Permit Number: 061424

has permission to New Single Family Home - w/ 2 Car garage

AT STEPPING STONE LN #6 #29 DISTRICT 406 F056001

ONE AND TWO FAMILY	PLAN REVIEW	CHECKLIST
Soil type/Presumptive Load Value (Table R401.4.1)	Submitted Plan	Findings
Component	Submitted Plan	Revisions
STRUCTURAL	Submitted Plan	Revisions
Footing Dimensions/Depth (Table R403.1 & R403.1(1), (Section R403.1 & R403.1.4.1)	Submitted Plan	Findings
Foundation Drainage, Fabric, Damp proofing (Section R405 & R406)	Submitted Plan	Revisions
Ventilation/Access (Section R408.1 & R408.3) Crawls Space ONLY	Submitted Plan	Revisions
Anchor Bolts/Straps, spacing (Section R403.1.6)	Submitted Plan	Findings
Lally Column Type (Section R407)	Submitted Plan	Revisions
Girder & Header Spans (Table R 502.5(2))	Submitted Plan	Findings
Built-Up Wood Center Girder	Submitted Plan	Revisions
Dimension/Type	Submitted Plan	Findings
Sill/Band Joist Type & Dimensions	Submitted Plan	Findings
First Floor Joist Species	Submitted Plan	Findings
Dimensions and Spacing (Table R502.3.1(1) & Table R502.3.1(2))	Submitted Plan	Findings

LOT 6 - GRADING PLAN
 AUTUMN GLEN SUBDIVISION

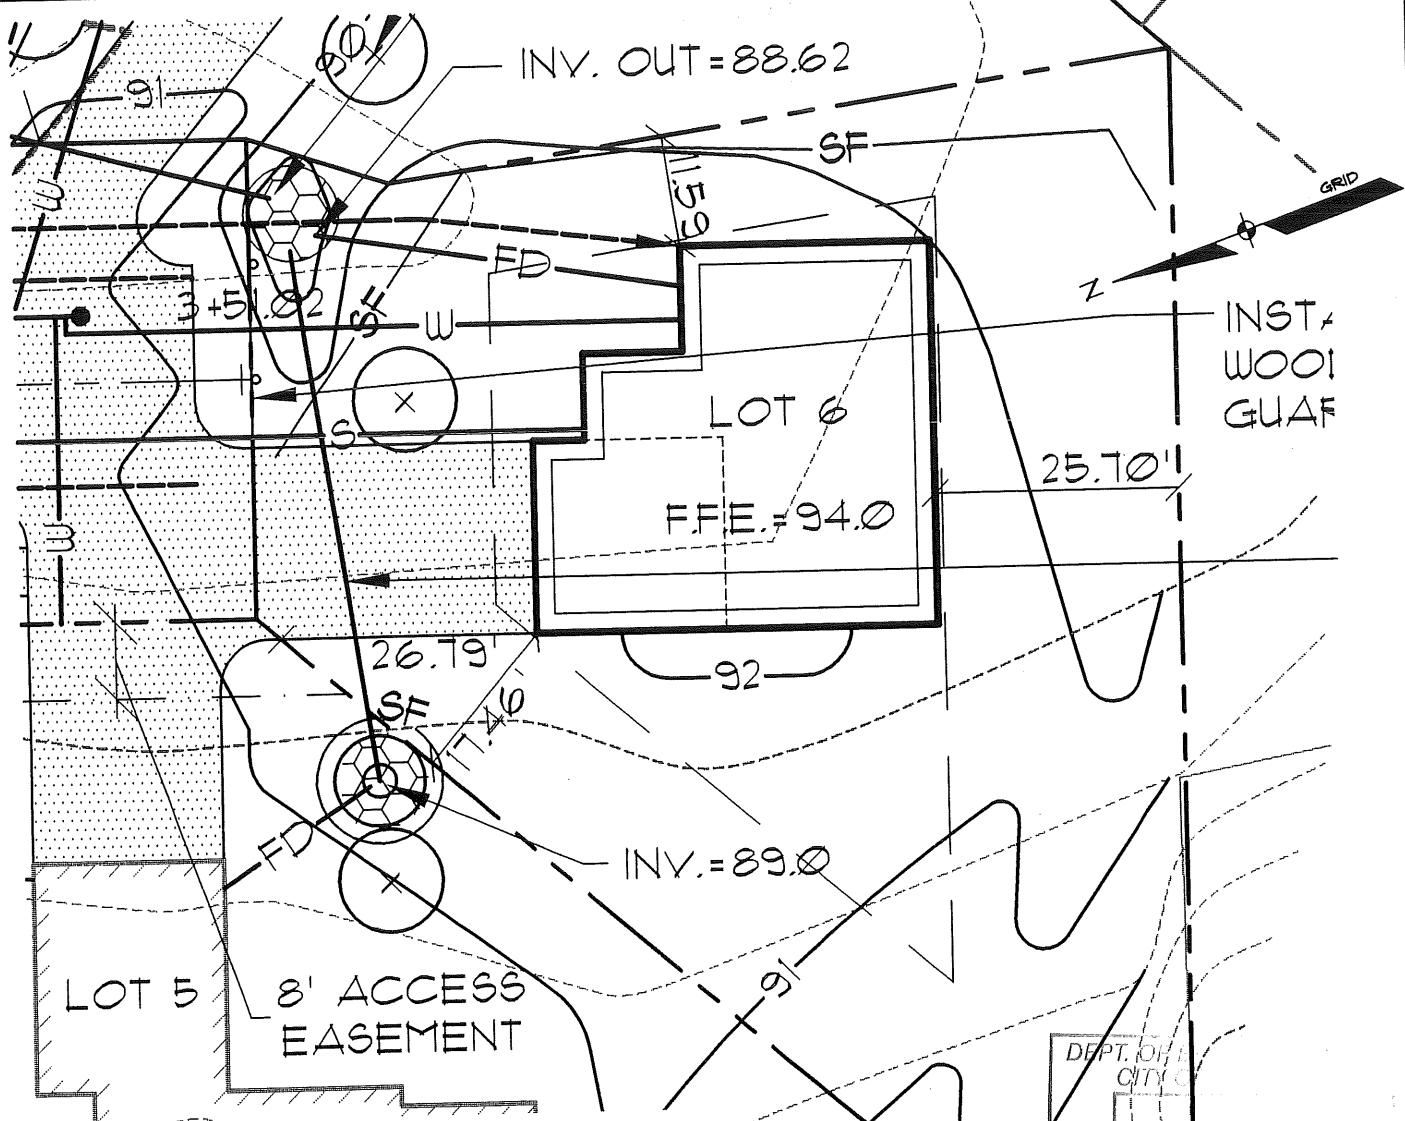
10/4/2006-amachado: Left message for King Weinstein to call me. Front setback is not met. Scales at 24.5' not the required 25' and the elevationn plans show a daylight basement in the back, but the grading plan does not match this.

10/6/2006-amachado: Received revised site plan. Meets zoning requirements. Still waiting for correct elevation plans.

FIRST FLOOR PLAN
 THE BREWSTER

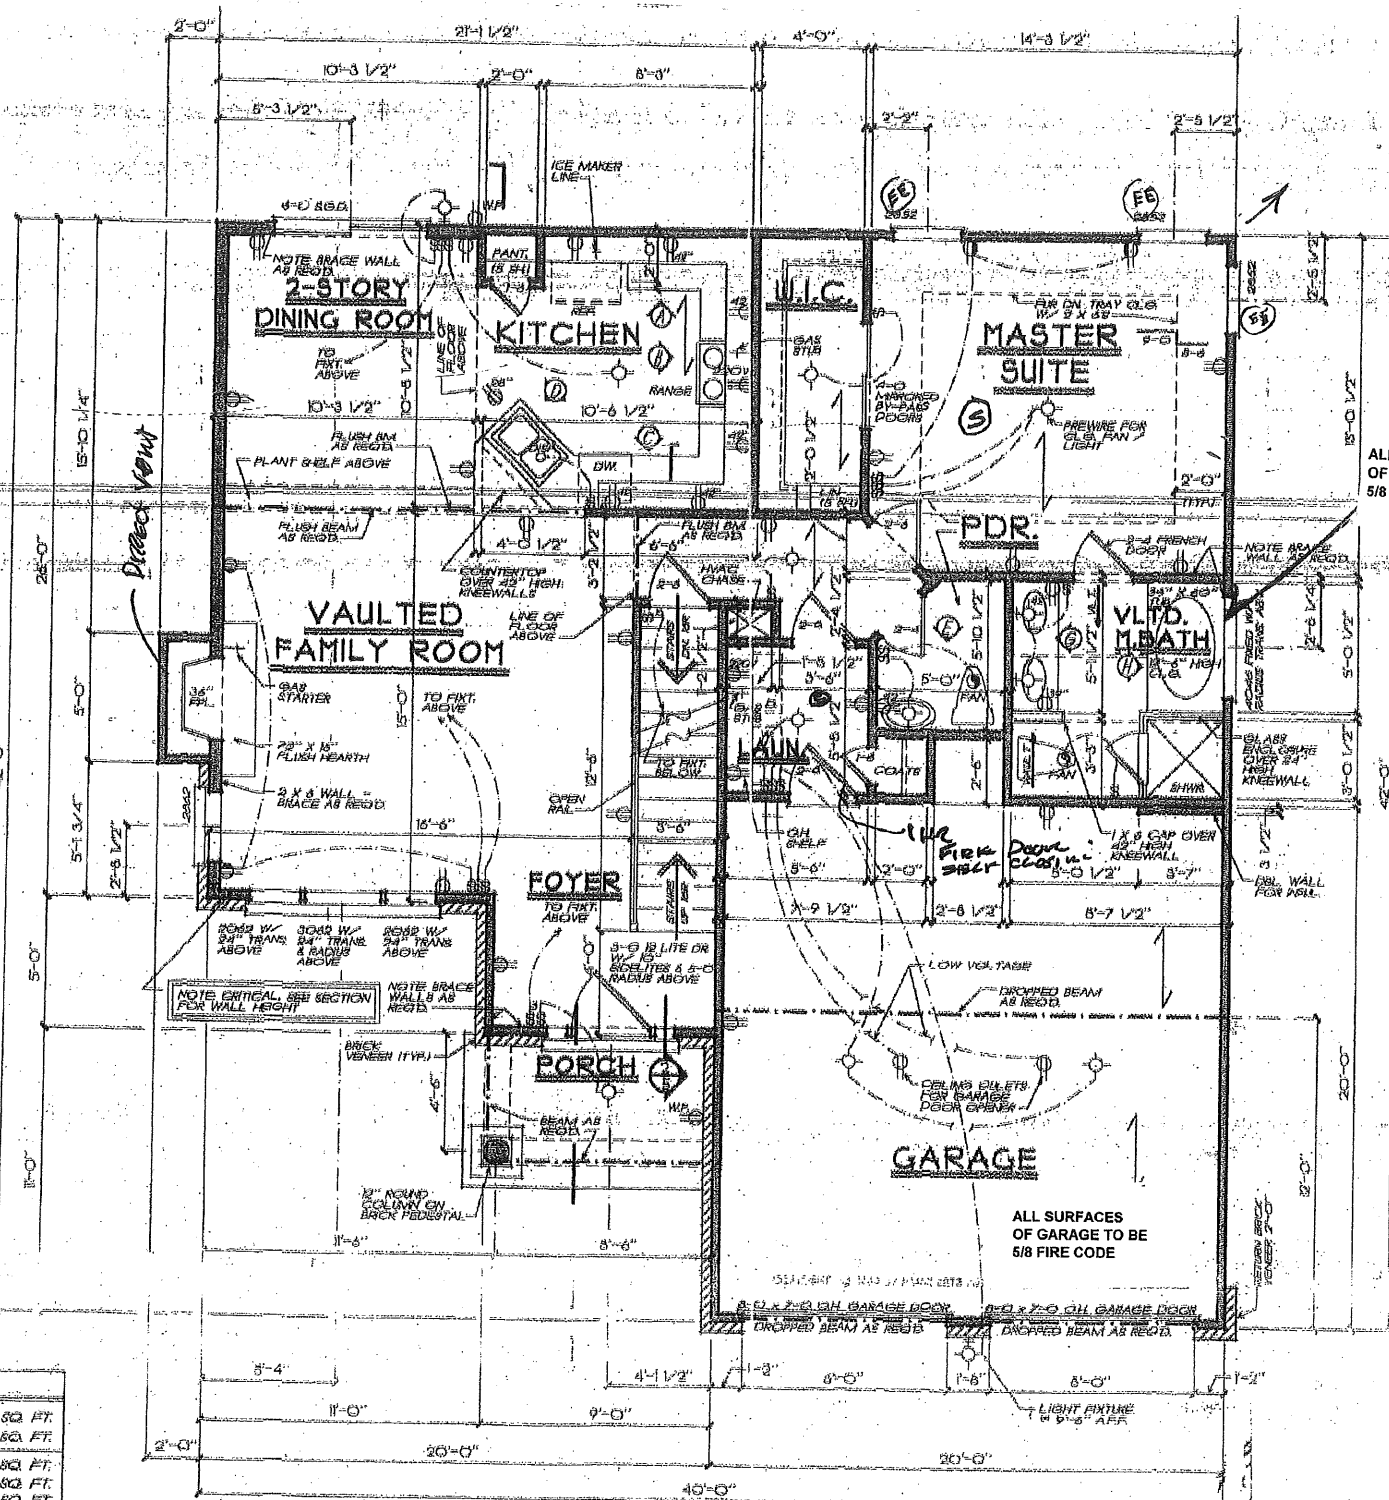
<p>④ Pitch, Span, Spacing & Dimension (Table R802.5.1(1), R 802.5.1(8)) Roof Rafter; Framing & Connections (Section R802.3 & R802.3.1)</p>	<p>5/8" - Rafters - undersized beam under splice</p>	<p>+ if there is a point. 2x6 Detail 45-5/8"</p>
<p>⑤ Sheathing; Floor, Wall and roof (Table R503.2.1.1(1))</p>	<p>5/8" - Roof 1/2" - floors? walls?</p>	<p>2 1/2" - 3/4"</p>
<p>⑥ Fastener Schedule (Table R602.3(1) & (2))</p>	<p>Per IRC</p>	
<p>⑦ Private Garage (Section R309) Living Space? (Above or beside)</p>	<p>- Yes</p>	
<p>⑧ Fire separation (Section R309.2)</p>	<p>Hand noted on sheet 3 - 5/8" F.C. Tyrex - all surfaces w/ fire door</p>	<p>Noted on Prints 314 (EE)</p>
<p>⑨ Opening Protection (Section R309.1)</p>	<p>not shown</p>	
<p>⑩ Emergency Escape and Rescue Openings (Section R310)</p>	<p>not shown</p>	
<p>⑪ Roof Covering (Chapter 9)</p>	<p>Asphalt?</p>	<p>OK</p>
<p>⑫ Safety Glazing (Section R308)</p>	<p>Need in master bath</p>	<p>Noted on Print 4</p>

SHEET: **5**

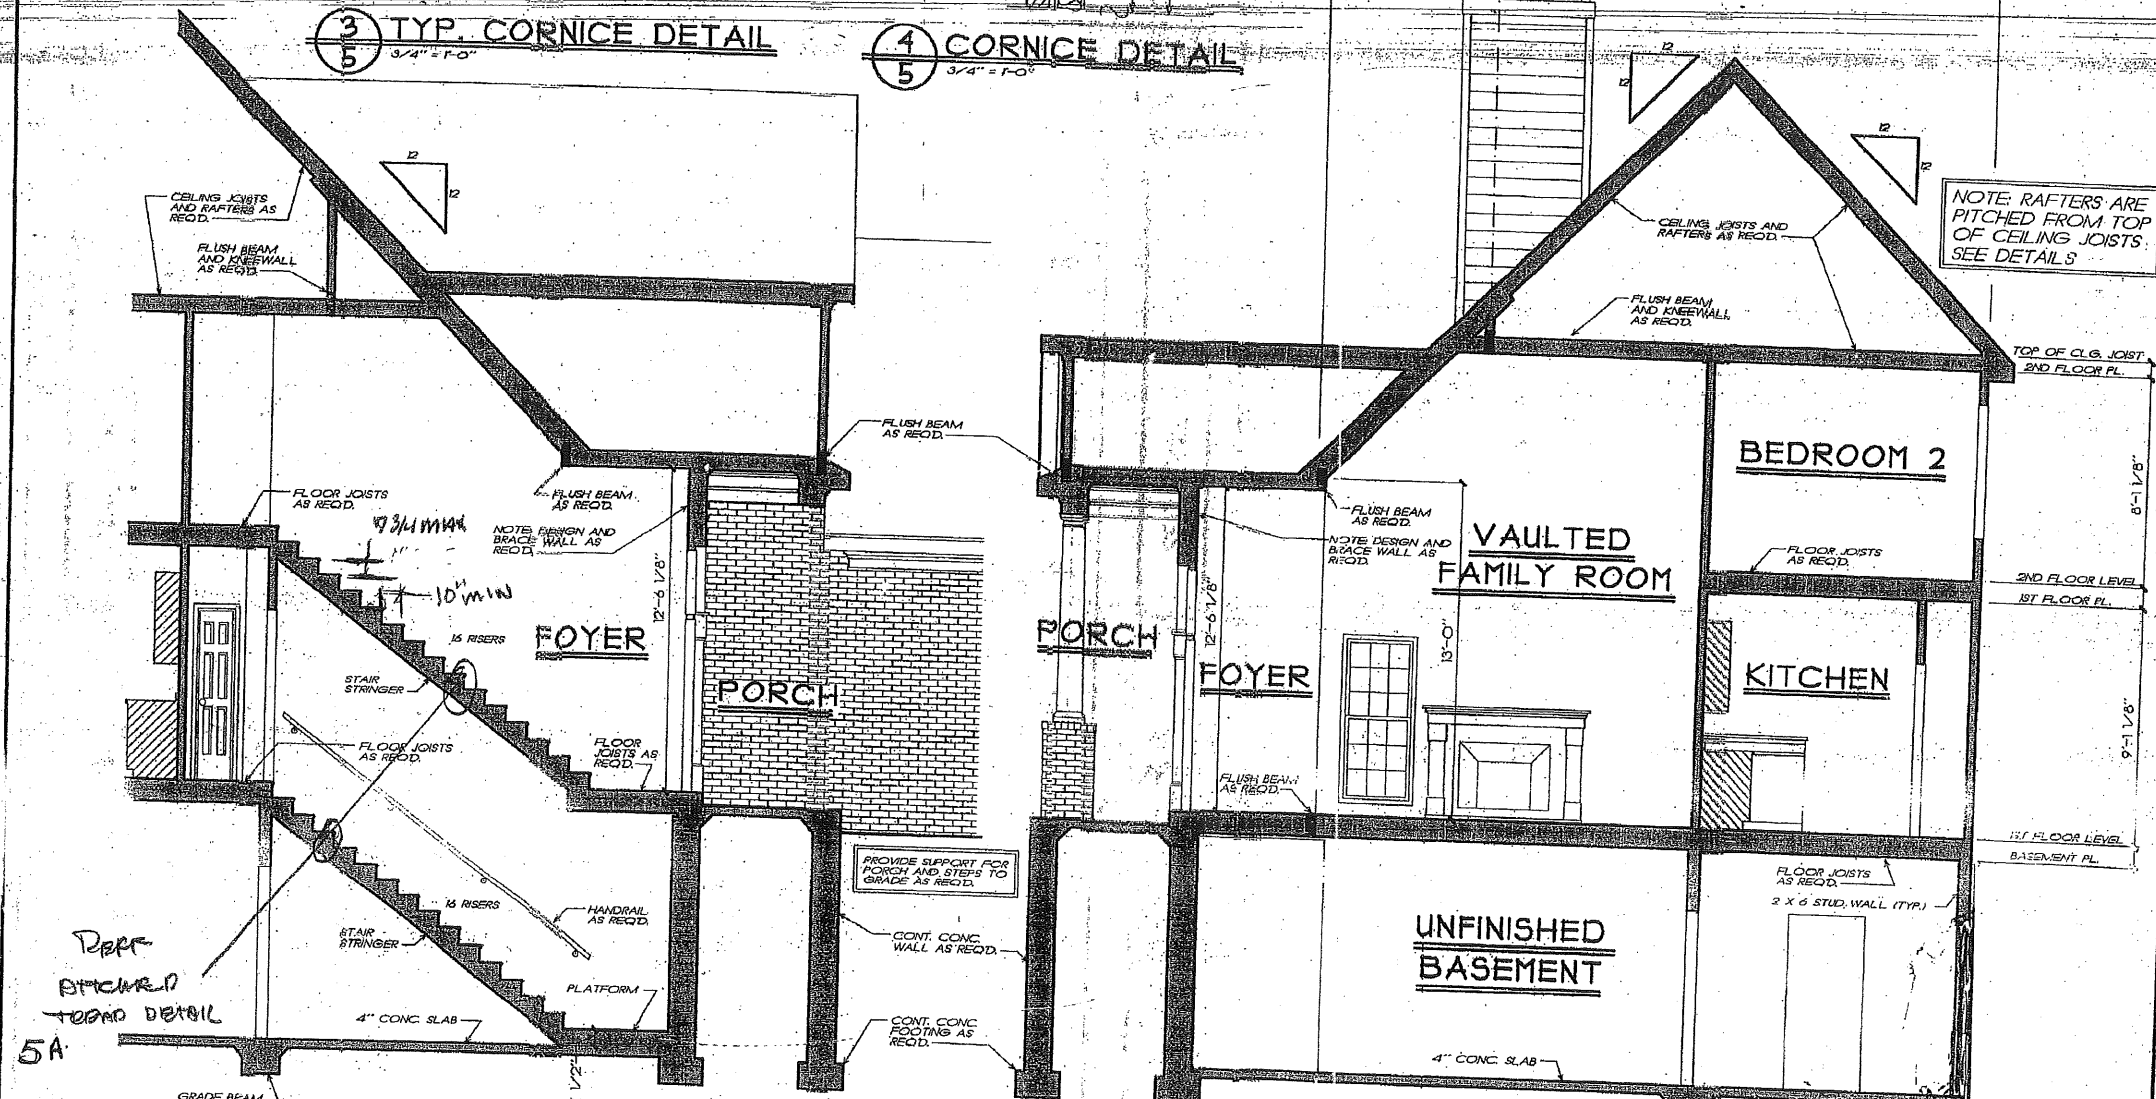
<p>⑬ Attic Access (Section R807)</p>	<p>size?</p>	<p>2' x 6' Panel - OK</p>
<p>⑭ Chimney Clearances/Fire Blocking (Chap. 10)</p>	<p>N/A</p>	
<p>⑮ Header Schedule (Section 502.5(1) & (2))</p>	<p>not shown</p>	<p>Noted on Print 5A</p>
<p>⑯ Energy Efficiency (N1101.2.1) R-Factors of Walls, Floors, Ceilings, Building Envelope, U-Factor Fenestration</p>	<p>not shown</p>	<p>RET PRINT 5A - R19 IS FROM ONLY</p>
